RE: LFPCN 41287

Subject: **Littelfuse SMTAK3 Series Height Optimization Notification**

3.0 Datasheet update summary:

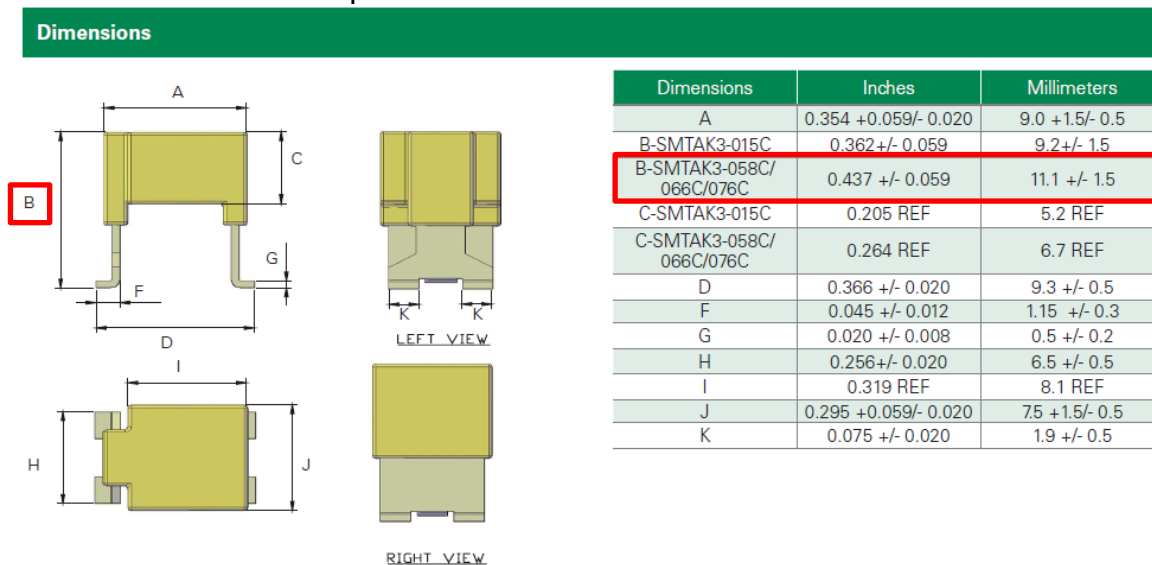
Dimension B on datasheet optimized from 0.437 +/- 0.059 inch (11.1 +/- 1.5 mm) to 0.394 +/- 0.039 inch (10.0 +/- 1.0 mm) and no any change of product electrical parameters, reliability and other dimensions.

Current dimensions on published datasheet:

Updated after optimization on published datasheet:
